DEVELOPMENT REVIEW BOARD MEETING

**DEVELOPMENT REVIEW BOARD
RESOLUTION NO. 441**

DB25-0002 Class 3 Sign Permit and Wall Mural for ParkWorks: Class 3 Sign Permit (SIGN25-0007), Waiver (WAIV25-0001), and Site Design Review (SDR25-0002).

Exhibit A1
Planning Division Staff Report
Class 3 Sign Permit and Wall Mural for ParkWorks

Proposed 355 sq. ft. sign

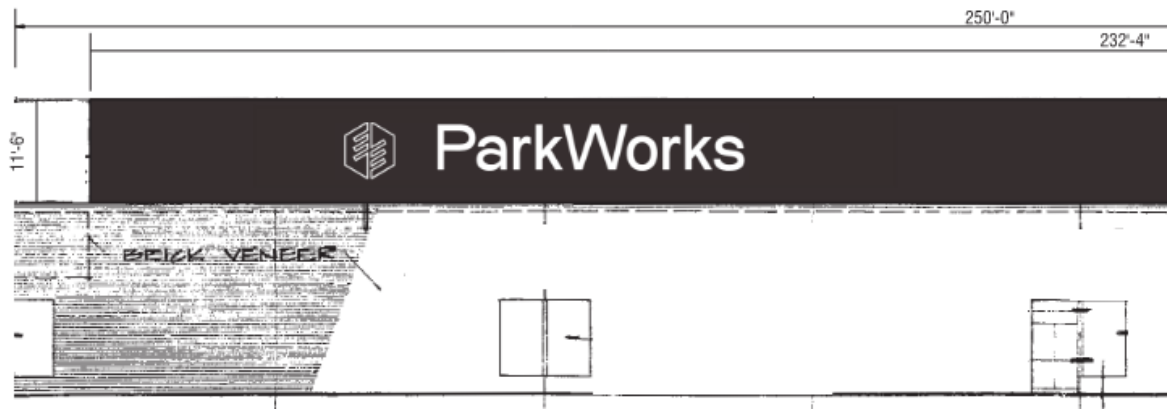
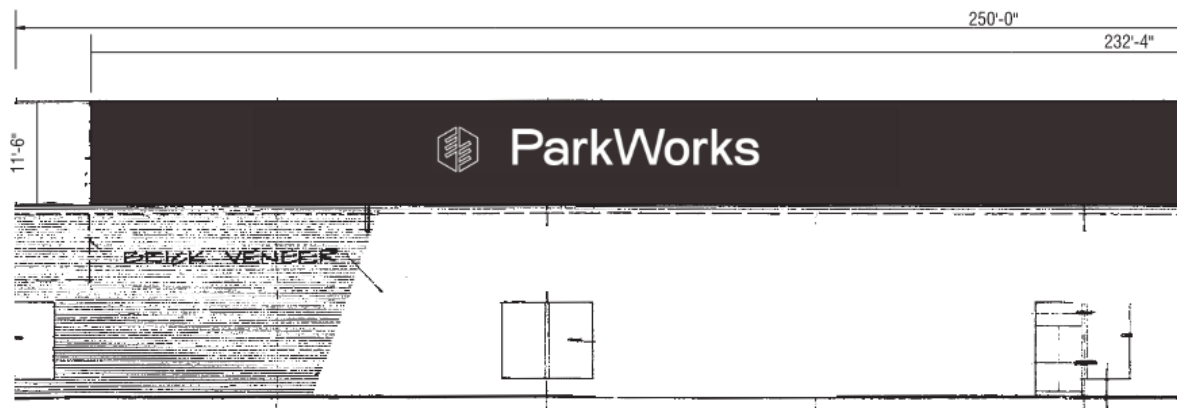
The three images above demonstrate how the relationship between the size of the sign and the architectural feature in which they are placed changes the visual impact of the sign. In the first image the 355 sq. ft. sign dominates the parapet and does not appear to be balanced. Whether there is sufficient definable space is questionable as the sign appears to be “pushing” against the upper edge of the parapet.

The second image illustrates the staff’s recommendation to limit the extent of the waiver to allow for a maximum of 200 sq. ft. The 200 sq. ft. sign balances positive and negative space appropriately. There is noticeable definable space between the sign and the edges of the parapet. The sign does not appear to dominate the architectural feature but instead it adds interest to an otherwise plain façade enhancing the design.

The third image depicts the sign at 132 sq. ft., the maximum allowed sign area based on the length of the façade. The smaller sign does not fill the parapet as well as the 200 sq. ft. sign.

While there is definable space, an argument can be made that too much is provided throwing off the balance between the positive and negative space.

PDA 1.	Ongoing: The approved sign shall not exceed 200 sq. ft. and be installed in a manner substantially similar to the sign approved by the DRB and stamped plans approved by the Planning Division.
PDA 2.	Prior to Installation: The applicant shall submit a Class 1 Sign permit including drawings demonstrating compliance with the DRB approval

Proposed 355 sq. ft. sign

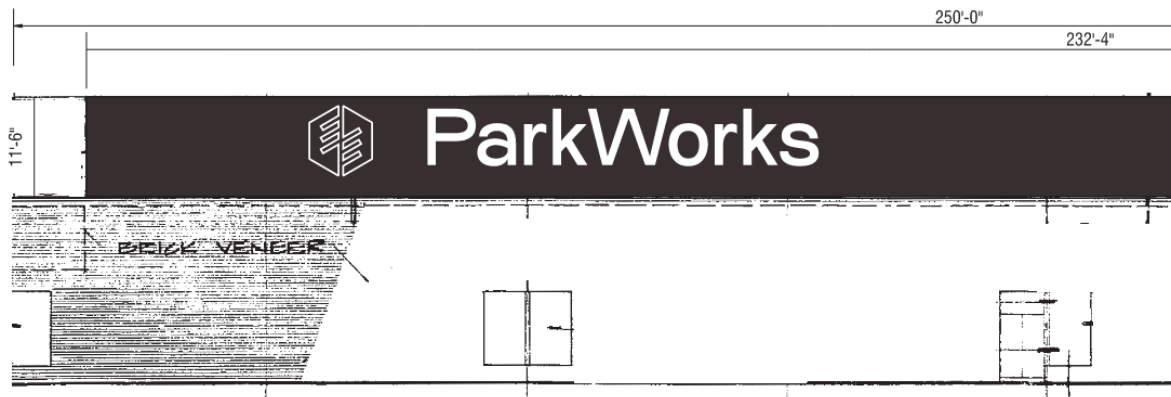
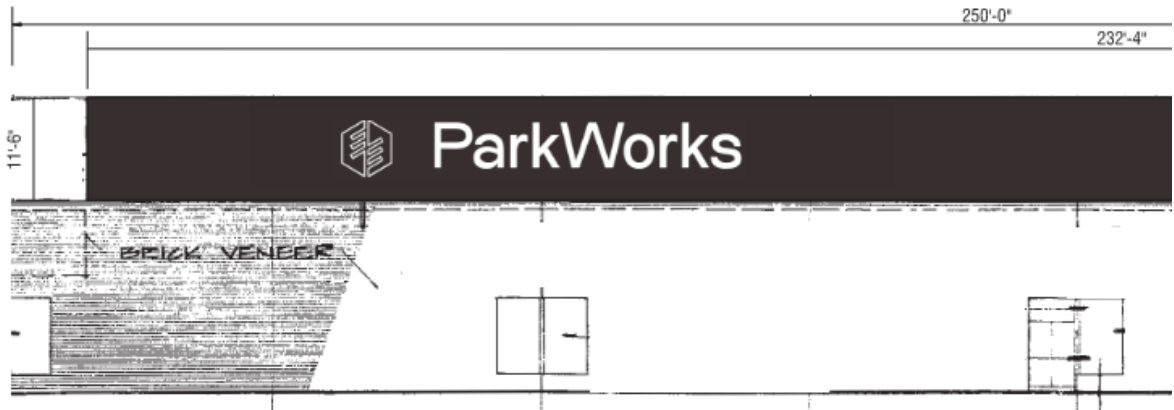
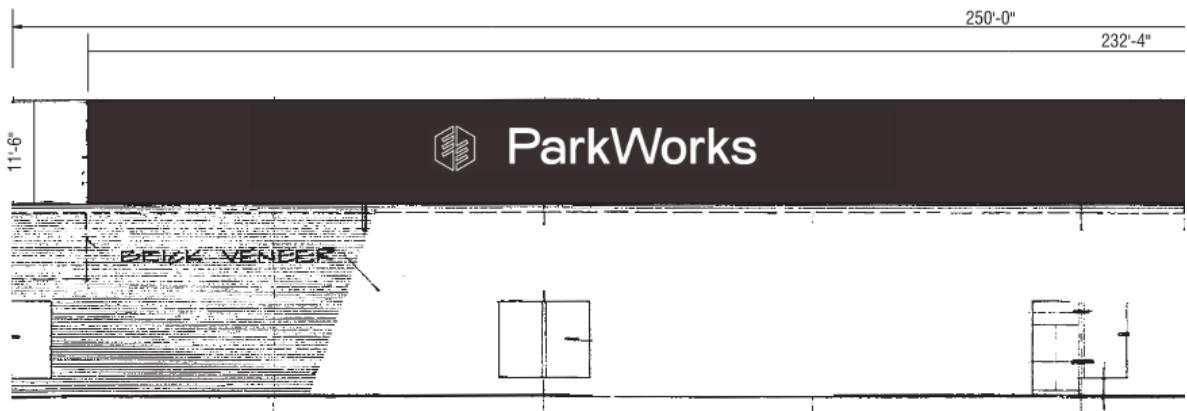
As mentioned above, the 355 sq. ft. sign does not allow for appropriate definable space between the sign and the edges of the parapet. Staff completed an analysis with mockups demonstrating the visual impact of providing appropriate definable space as it relates to the architectural feature in which the ParkWorks sign is proposed. See the images below demonstrating the appearance of the sign at 355 sq. ft., 200 sq. ft., and 132 sq. ft.

The three images above demonstrate how the relationship between the size of the sign and the architectural feature in which they are placed changes the visual impact of the sign. In the first image the 355 sq. ft. sign dominates the parapet and does not appear to be balanced. Whether there is sufficient definable space is questionable as the sign appears to be “pushing” against the upper edge of the parapet creating a constricted feeling.

The second image illustrates the staff’s recommendation to limit the extent of the waiver to allow for a maximum of 200 sq. ft. The 200 sq. ft. sign balances positive and negative space appropriately. There is noticeable definable space between the sign and the edges of the parapet. The sign does not appear to dominate the architectural feature but instead it adds interest to an otherwise plain façade enhancing the design.

The third image depicts the sign at 132 sq. ft., the maximum allowed sign area based on the length of the façade. The smaller sign does not fill the parapet as well as the 200 sq.

ft. sign. While there is definable space, an argument can be made that too much is provided throwing off the balance between the positive and negative space.

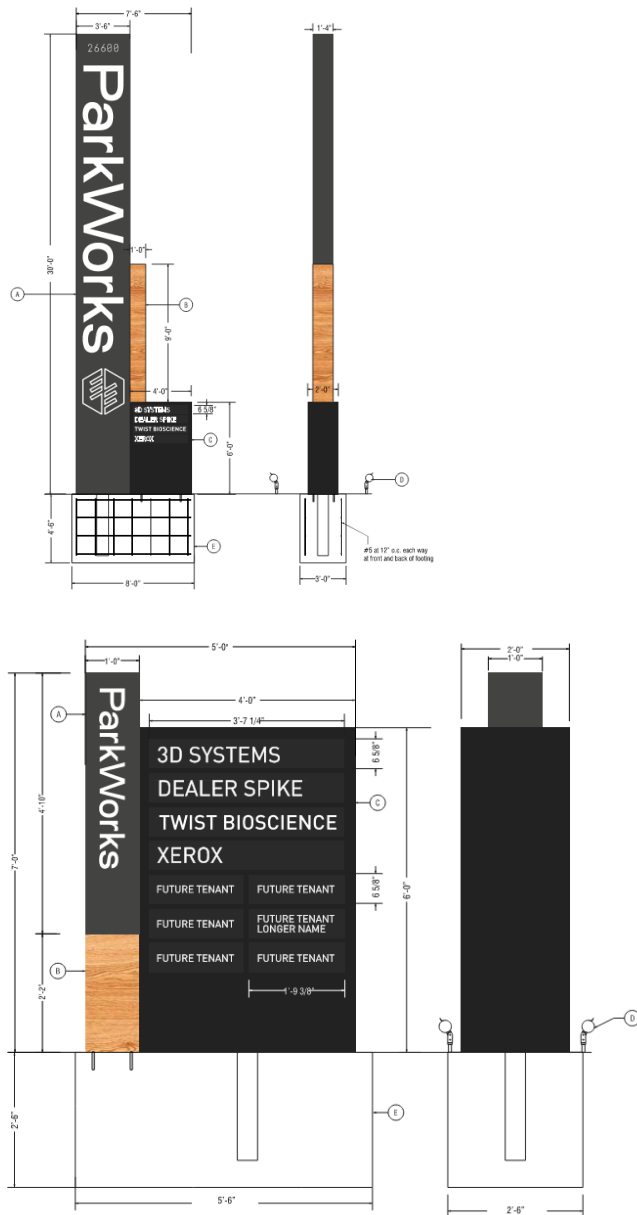
The painted design of the sign, which will be painted in matte white directly on the upper grey/black portion of the façade, is a unique feature that is compatible with the existing aesthetics of the industrial campus and more subtle in style than a traditional building sign using channel letters, sign cabinets and a variety of colors as it is integrated within the architectural features of the development without vertical separation. The west façade of the existing building is plain with few architectural details, relying mainly on the use of contrasting materials to create interest. The addition of the sign will add interest while breaking up the façade. The angular roofline of the façade provides a visual break in the parapet creating a space to be "filled" which speaks to the need for a larger sign.

However, a 355 sq. ft. sign would be dominating and out of sync with the architecture of the building. Limiting the sign to 132 sq. ft. also calls into question whether balance between the wall sign architectural feature can be achieved. The parapet provides natural boundaries for the sign to fit within. The smaller sign results in more negative space surrounding the sign. A balance should be struck between the need to fill the architectural feature and the requirement that the sign is complementary and compatible with the building's design. The sign should fit snugly but not appear cramped. For that reason, staff recommends a Condition of Approval limiting the sign to 200 sq. ft. . See Findings A5 and A10. for an in-depth analysis of the signs compatibility in relation to size and placement within the buildings architectural features.
